**STAFF RECOMMENDATION**

**1514 Clayton Avenue**

**February 21, 2018**

**Application:** New construction- infill; Demolition

Figure 1: 1514 Clayton Avenue

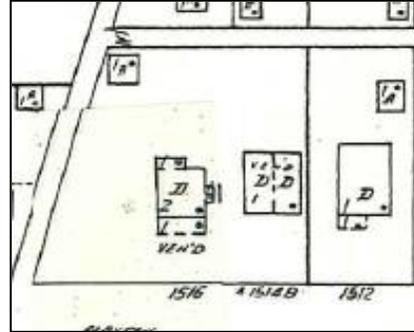
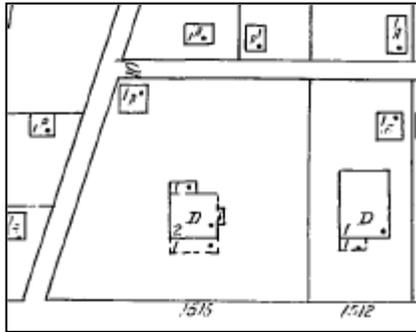
**Background:** The house at 1514 Clayton Avenue is a 1950s house that does not contribute to the historic context of the Belmont - Hillsboro Neighborhood Conservation Zoning Overlay (Figure 1). At fifty feet (50') wide, the subject property is the narrowest lot on Clayton Avenue between Belmont Boulevard and Granny White Pike/12<sup>th</sup> Avenue South.

**Demolition:** The house at 1514 Clayton Avenue was constructed between 1951 and 1957, as it does not appear on the 1951 Sanborn map but does on the 1957 Sanborn Map (Figures 2 & 3). This is outside the period of historic significance for the Belmont-Hillsboro neighborhood. In addition, the house lacks details common in historic Belmont-Hillsboro houses, like eave overhangs and porches. Staff finds that existing

Figure 4 shows the fenestration issues on the right side façade

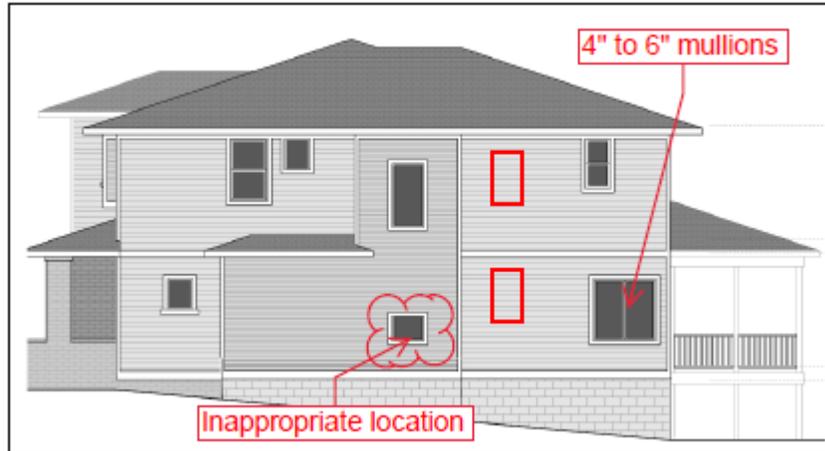
Proportion and Rhythm of Openings: The infill's fenestration pattern does not meet the historic context. A number of windows on the proposed infill are not twice as tall as they are wide; and, therefore, do not meet the historic proportion of windows. On the right elevation, the low window on the first floor, at about the midpoint, is not appropriate. Its location, so low on the wall, is not appropriate as it does not meet historic conditions for rhythm of openings. In addition, a four to six inch (4"-6") mullion is required in between the two windows towards the rear. See Figure 4 for illustration.

Figure 5 shows the fenestration issues on the left façade.

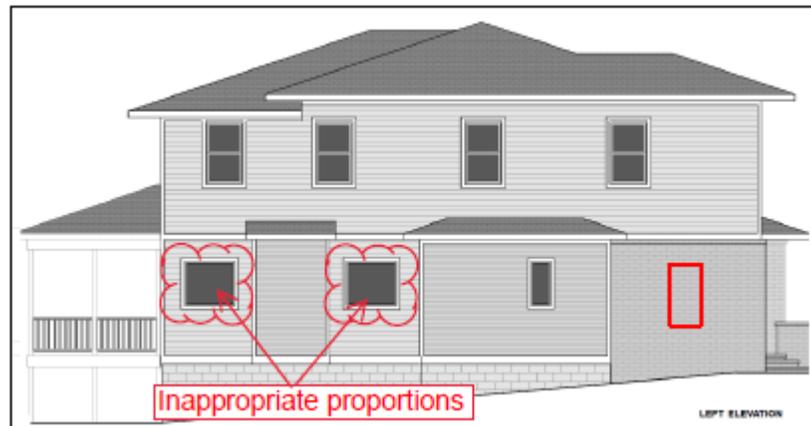
On the left elevation, there should be a window opening on the brick portion, first level, near the front of the house. In addition, the picture windows towards the back of the house are not twice as tall as they are wide, and therefore do not meet the historic proportion of window openings. See Figure 5 for illustration.
